**TRANSBAY TERMINAL /
CALTRAIN DOWNTOWN EXTENSION /
REDEVELOPMENT PROJECT**

**FINAL ENVIRONMENTAL IMPACT STATEMENT/
ENVIRONMENTAL IMPACT REPORT AND
SECTION 4(f) EVALUATION**

**WRITTEN PUBLIC COMMENTS AND
PUBLIC HEARING TRANSCRIPTS ON THE**

**Written Public Comments and
Public Hearing Transcripts on the
Transbay Terminal/Caltrain Downtown Extension/
Redevelopment EIS/EIR**

Figure 1

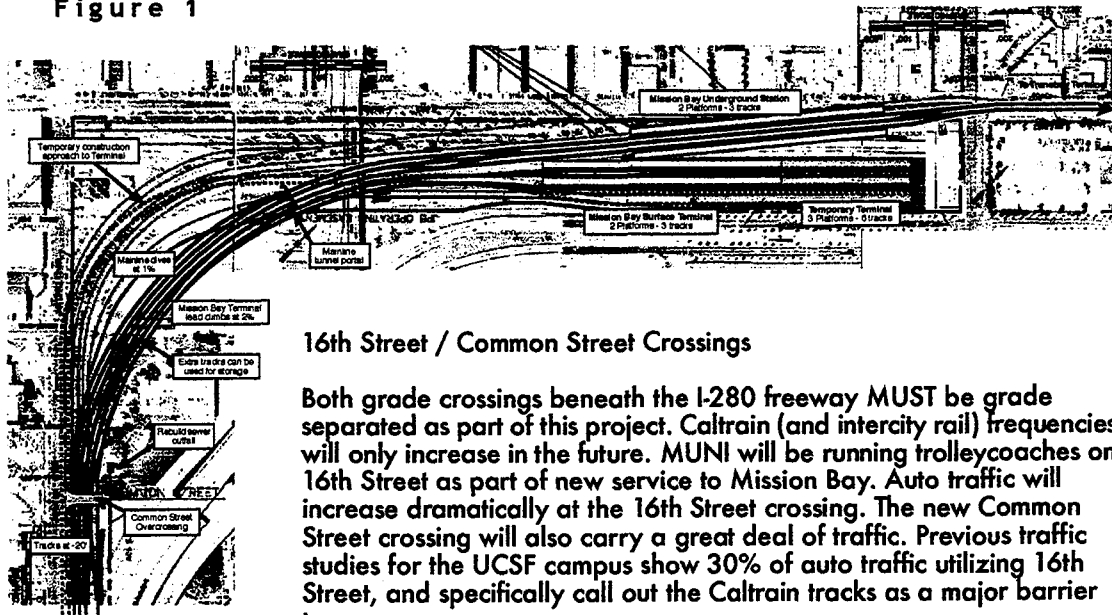
enough distance to allow the yard lead for the permanent Mission Bay surface station to climb back to the surface after passing under Common Street. The Mission Creek outfall will need to be rebuilt, but this is not a fatal flaw to the grade separation. These issues are illustrated in the attached Figure 1.

An equitable solution should be easy to reach with Catellus (the owner of the property at Mission Bay) to move the PCJBC operating easement to allow for the improvement of the curve. (See Figure 1) The property on the inside of the curve, which would be impacted by re-alignment of the curve, is hemmed in by the existing (and future tracks), the Sixth Street off-ramp from I-280, and the Mission Creek pumping plant. Moving the tracks to reduce the area of this parcel INCREASES the area of the outer parcel, which fronts on Townsend and Seventh Street, facing the edge of the Showplace Square neighborhood.

Figure 2

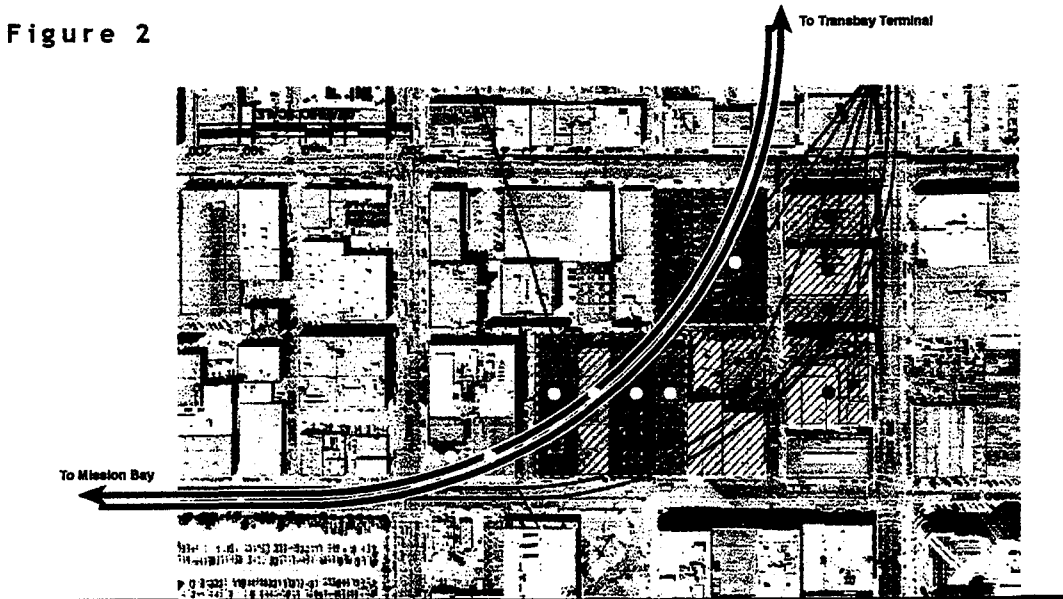
Starting in the Mission Bay area, shown on Figure 2, the alignment begins to turn to the north just west of Third Street. It passes directly beneath the first two buildings on the north side of Townsend Street, then the public ROW of Clarence Place, and then beneath the mid- to rear- portions of 166-168, 162-164, 148-154, and a very small portion of the rear of 144-146 Townsend Street. The ground-level above this alignment is slightly higher throughout, resulting in a deeper tunnel, further minimizing potential impacts on the structures at ground level.

Figure 5

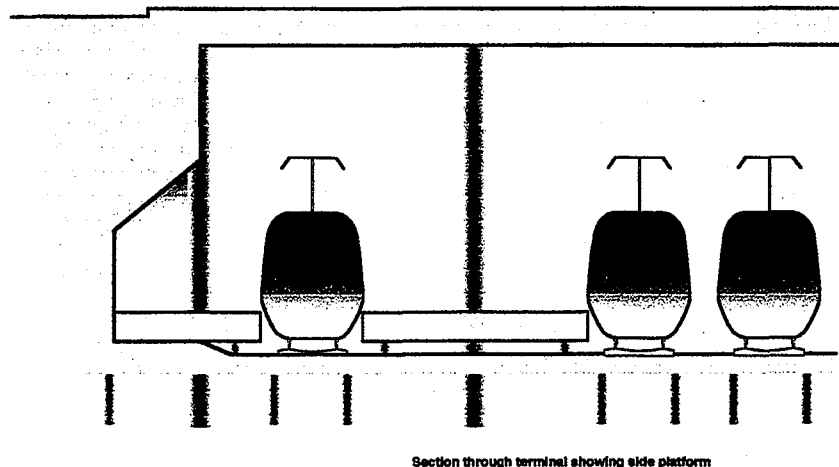
Another alteration to the proposed platform design is to change the arrangement of tracks and platforms from 3 platforms / 6 tracks, to 4 platforms / 6 tracks. This allows crossovers to be placed on all track pairs to allow 2 500' train consists to share the same platform. This increases capacity in the station and replaces the function of the discarded tailtracks. The side platforms, serving only one track each, would be narrower, and could be excavated alongside the station box, to limit the total amount of excavation. See Figure 5.
